BEFORE THE PUBLIC UTILITY COMMISSION

Docket No. LC 79

2022 Integrated Resource Plan.

Staff Final Comments

Figure 1: Actual and Modeled Forest Grove Average Daily Inlet Pressure vs Temperature⁴⁰

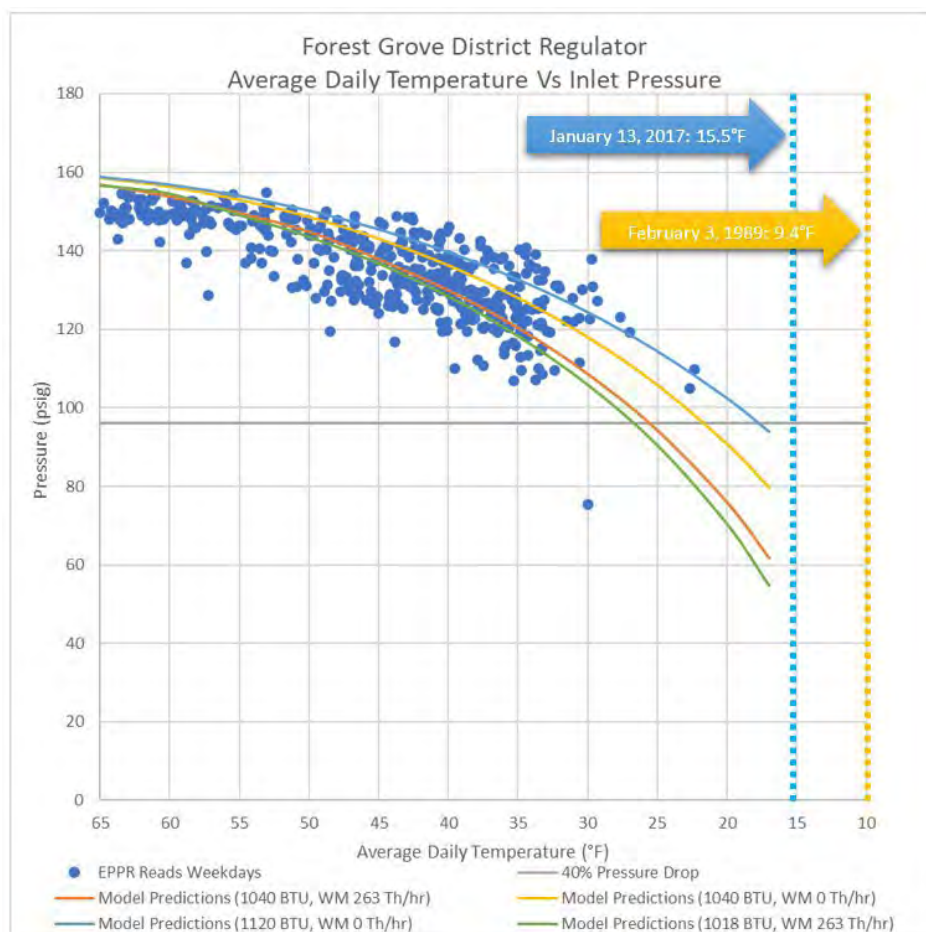
As shown in Figure 1, comparison of actual pressure data recordings at the District Regulator with the model results confirms a close match with random scatter points around four forecasted temperature-pressure curves representing different scenarios of BTU value and largest customer load.

Figure 1 shows that if historical temperatures of 15.5°F and 9.4°F (occurring in 2017 and 1989, respectively) were to recur at present, significantly large pressure drops of the inlet pressure would be expected in accordance with any of the load combination scenarios.

among other factors.⁴¹ Staff is interested to understand more about the degree by which each these factors influence demand and the extent by which pressure will be affected by the change in these variables.

Recommendation 12: Staff requests that the Company, before the next IRP, provide statistical evidence of the significance of the variables that influence demand, and hence pressure, at a specific temperature.

Figure 8.2: Distribution System Planning Process – Peak Hour

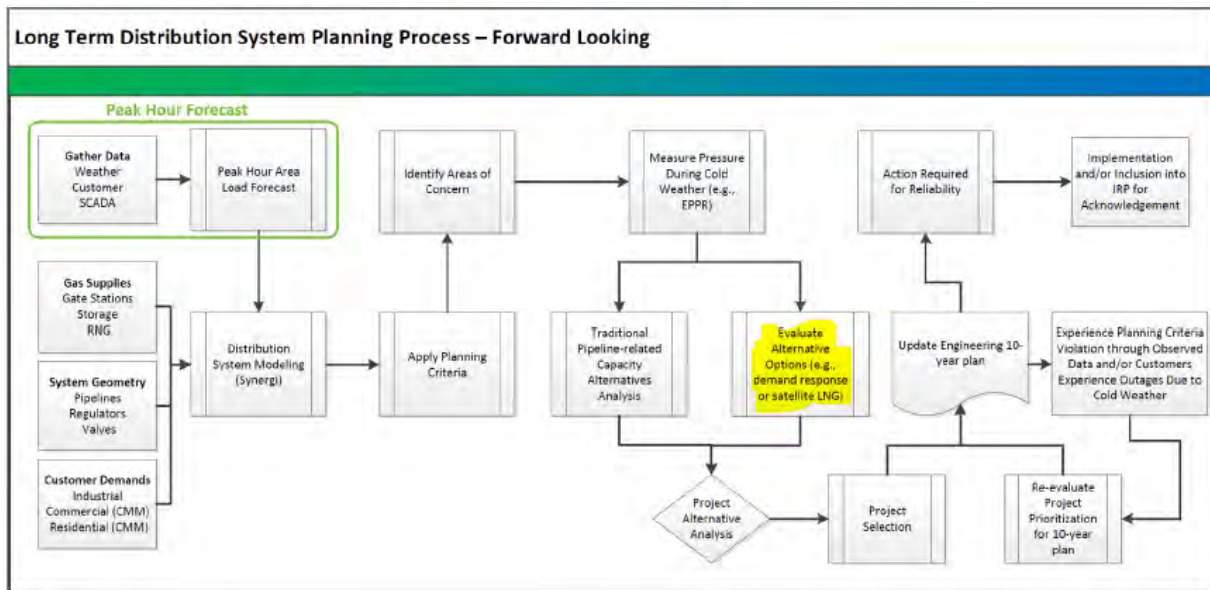
As demand side solutions require longer time to evaluate and analyze, presenting a project 2-3 years in advance does not give enough time for those alternative non-pipeline options to be considered on an equal footing.

Figure 3, Existing Demand Response Impact ⁶⁴

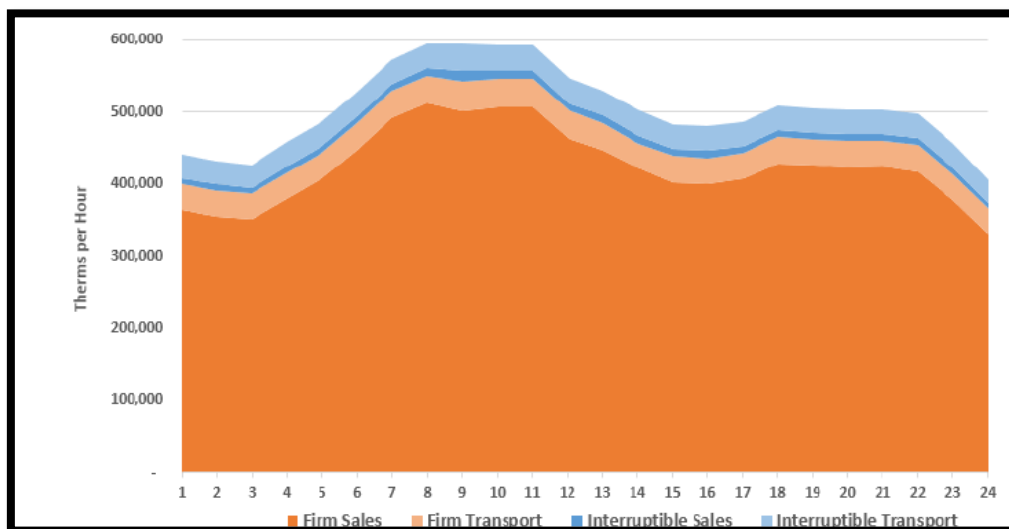
The figure above shows that approximately 2 percent of peak day sales load can be interrupted, and approximately 9 percent of total deliveries can be interrupted at peak.⁶⁵ To this end, Staff noted in its Opening Comments the extent to which future demand response capabilities naturally align with both interruptible and transport customers to control peak demand.⁶⁶

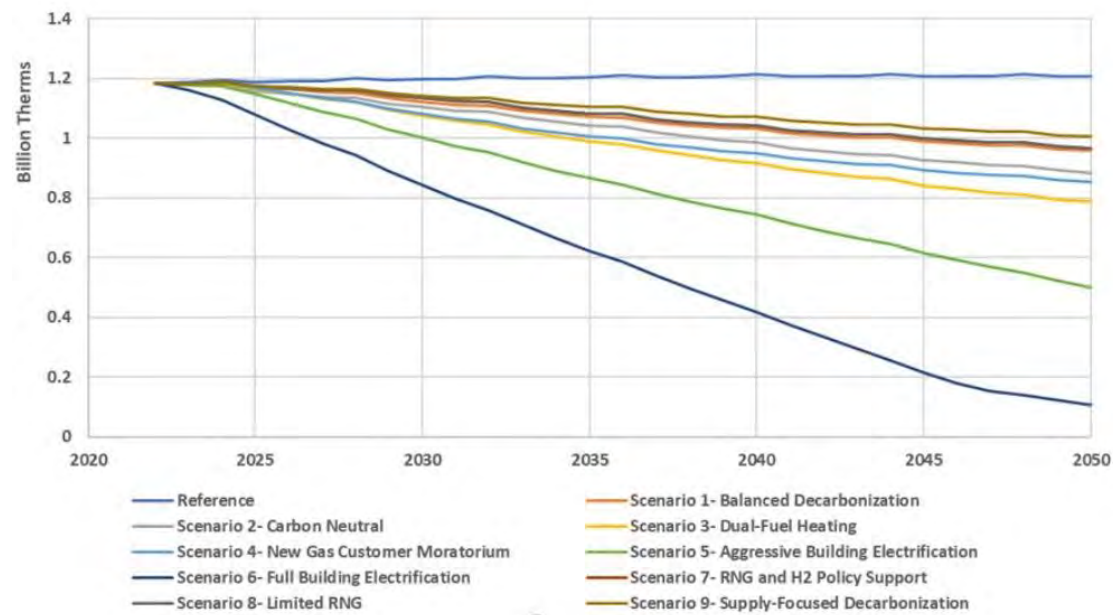
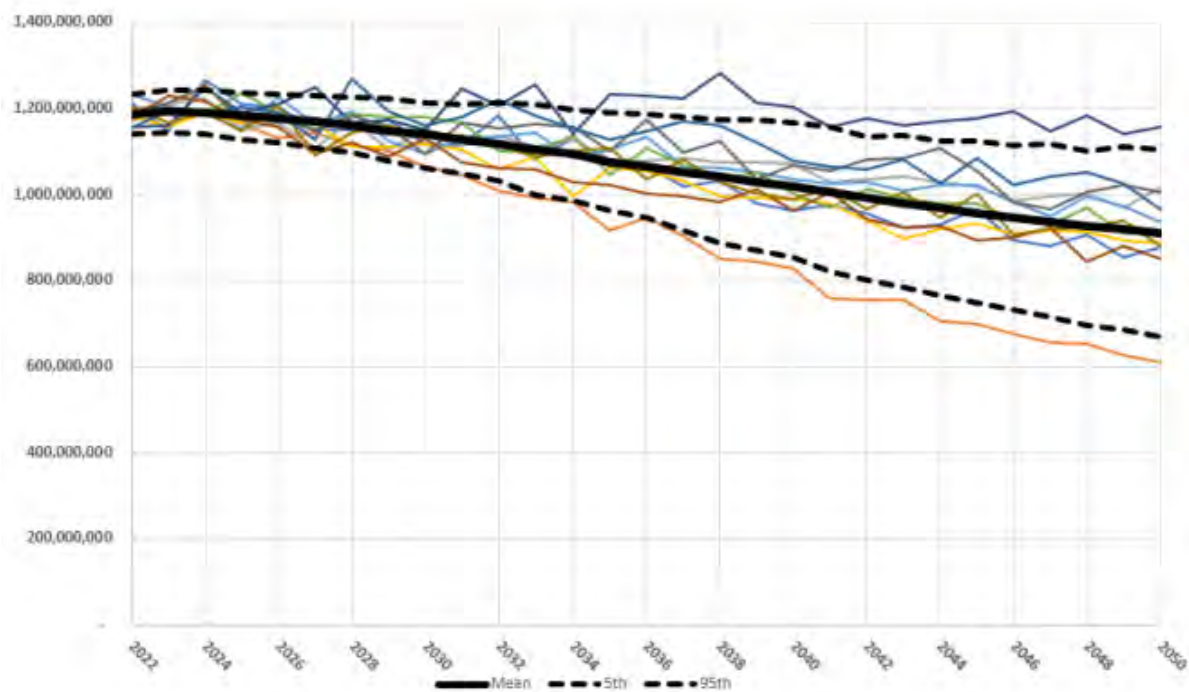
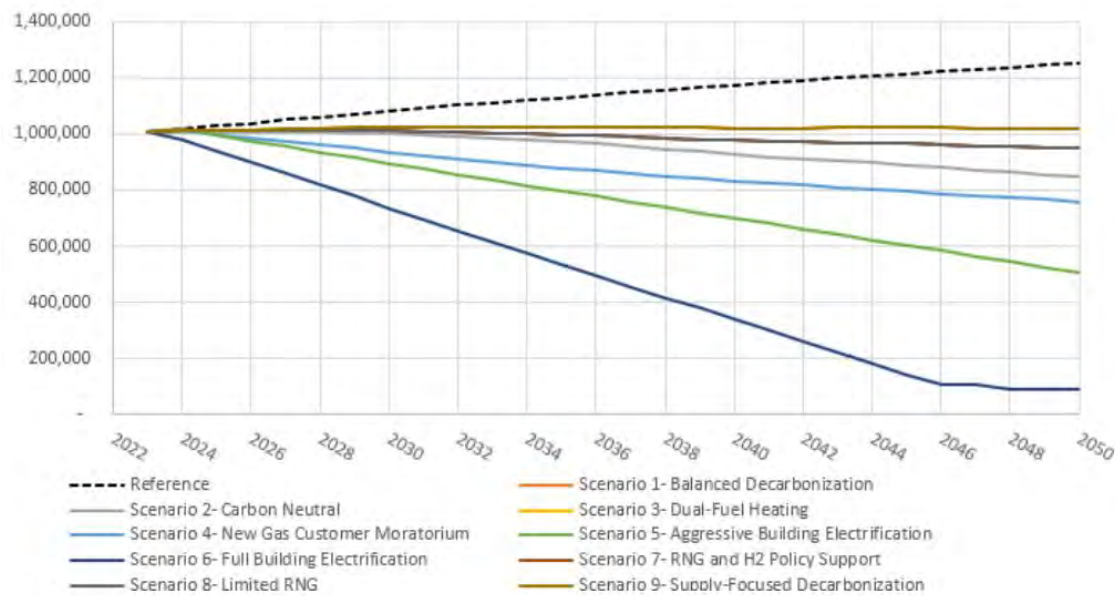
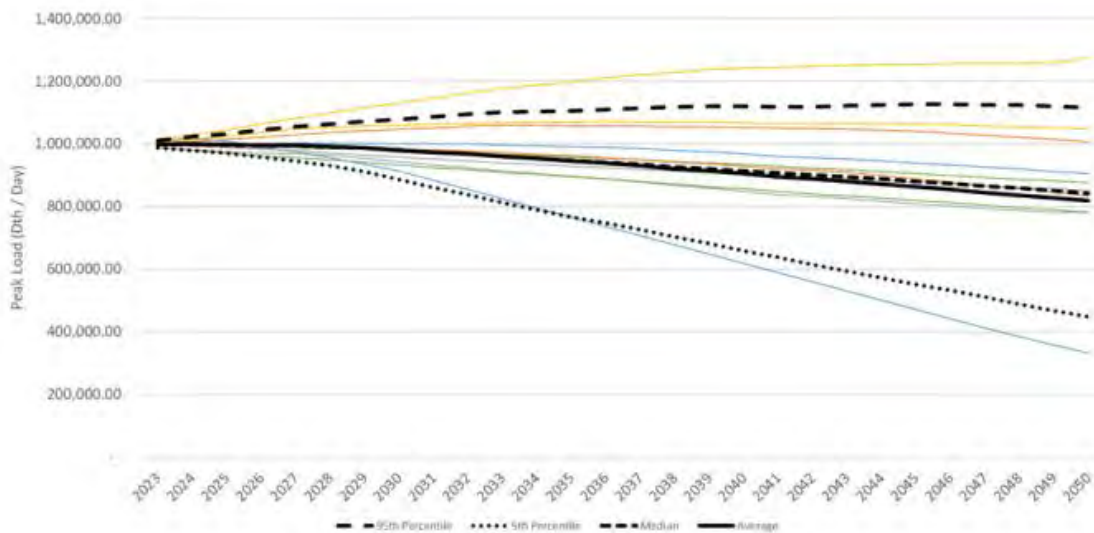
The annual energy deliveries forecasts (Figure 2 and Figure 3 above, corresponding to NWN Figures 3.38 and 3.40) illustrate that the preferred portfolio, which is the “average” line seen in the stochastic simulation (Figure 2, or NWN’s Figure 3.40), roughly aligns with the load trajectory seen in Scenario 1.

For the peak day forecast load, the preferred portfolio levels (Figure 5, or NWN’s Figure 3.42) are lower than the peak day load seen in Scenario 1 in Figure 4 (NWN’s Figure 3.41) and align roughly with Scenario 2.

Figure 13. NPV RR effect by scenario of substituting CCI credits for RNG, up to Allowed level of CCI credits

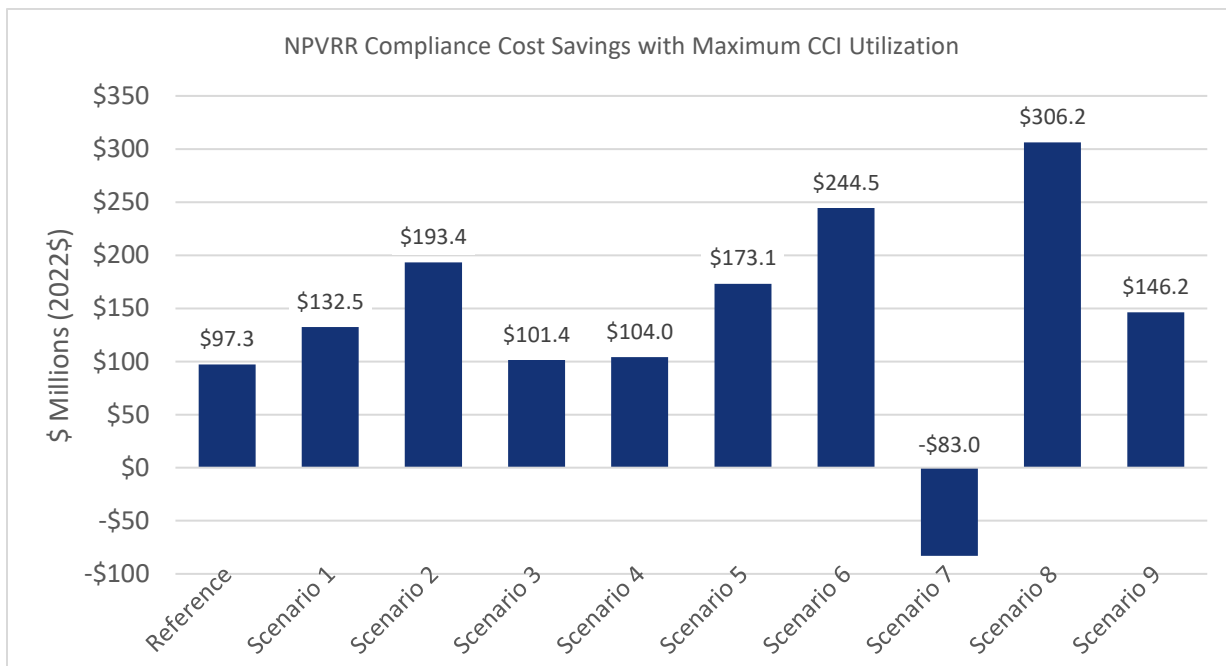
As seen in Table 4 and Table 5 above, the value of using CCI credits instead of procuring RNG to meet CPP compliance is at its highest when RNG costs are high, in Scenario 8. But in all scenarios except the low-cost RNG Scenario 7, using CCI credits at their maximum levels results in ratepayer savings.

Figure 18. Comparison of NPVRR across all scenarios, inclusive of electrification cost estimate, 2022-2050

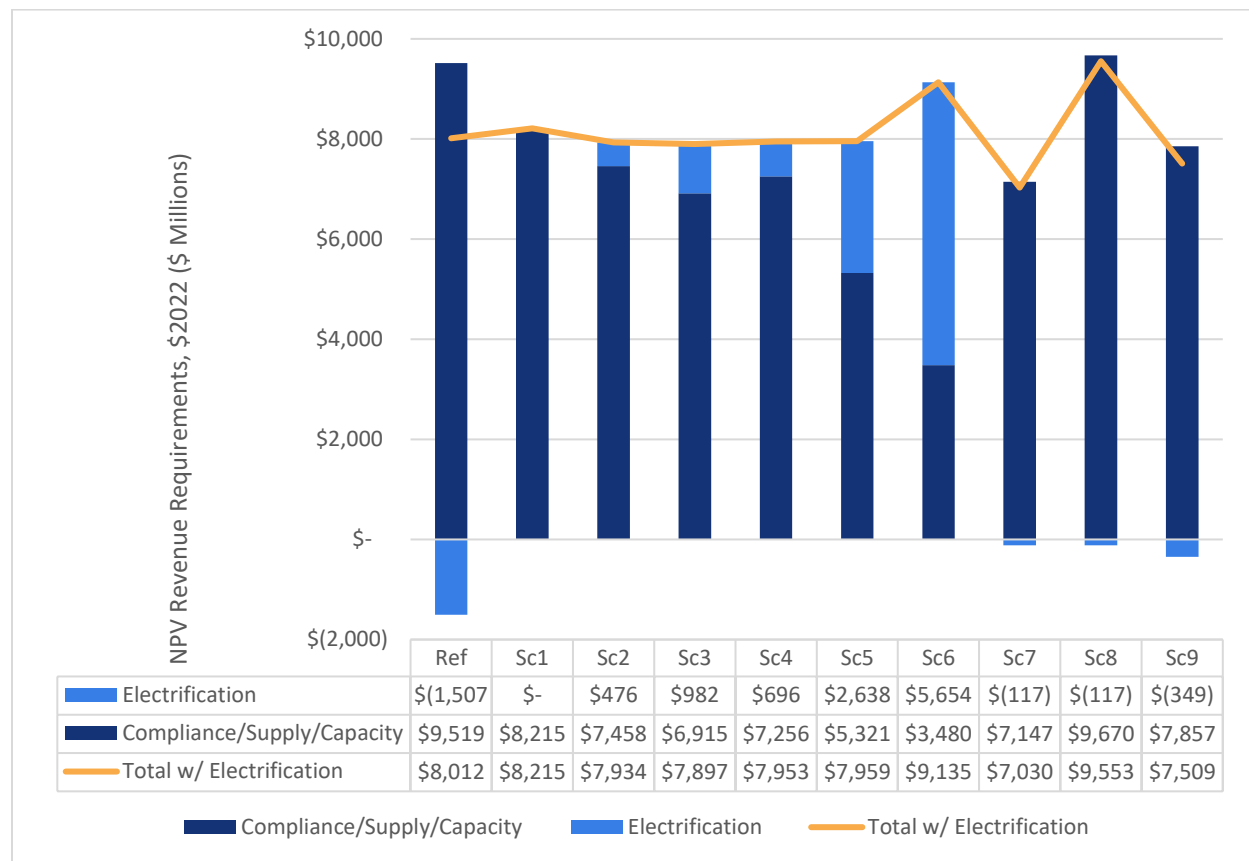
The two figures shown above, Figure 18 and Figure 19, demonstrate how directly considering the costs of load not served by gas, but served by electricity, allows for a rough comparison across scenarios to gauge the relative value of planning solutions using RNG versus solutions with electrified load. These two paths result in the same, or at least analytically similar, levels of decarbonization. Uncertainty associated with the level of decarbonization resides in each pathway. For electrification pathways, there is uncertainty with the marginal greenhouse gas emissions associated with increased electrification-derived load. For RNG pathways, there is uncertainty associated with the true level of net emissions associated with the combustion of RNG. NWN does not directly address this risk in its analysis.

Figure 19. NPVRR comparison with electrification costs, CCI-for-RNG substitution, and distribution capex savings, 2022-2050

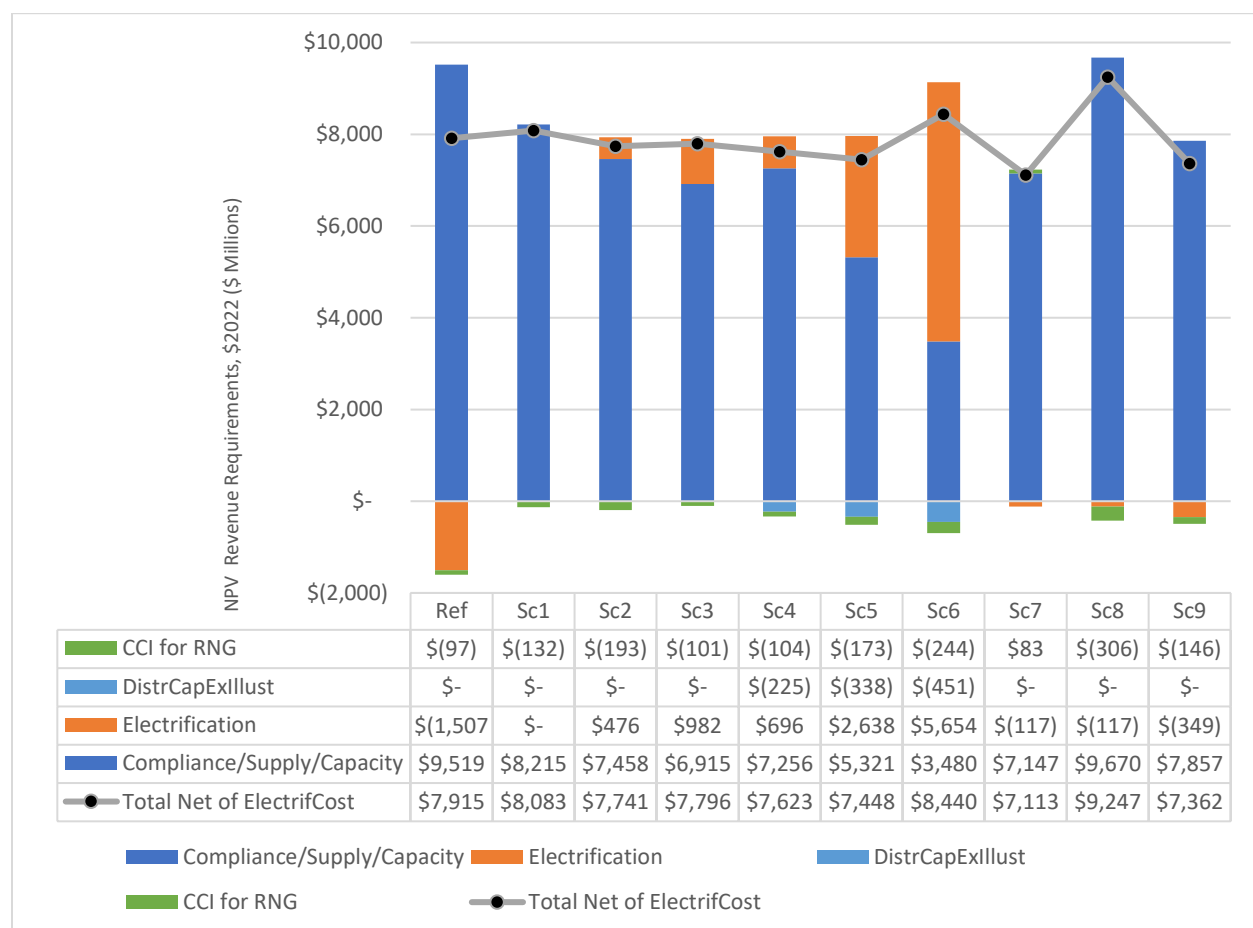
Figure 19 above illustrates that consideration of revenue requirement cost savings from alternative resource pathways can be used to compare outcomes against NWN's preferred scenarios, in this case using Scenario 1 to reflect NWN's preference.
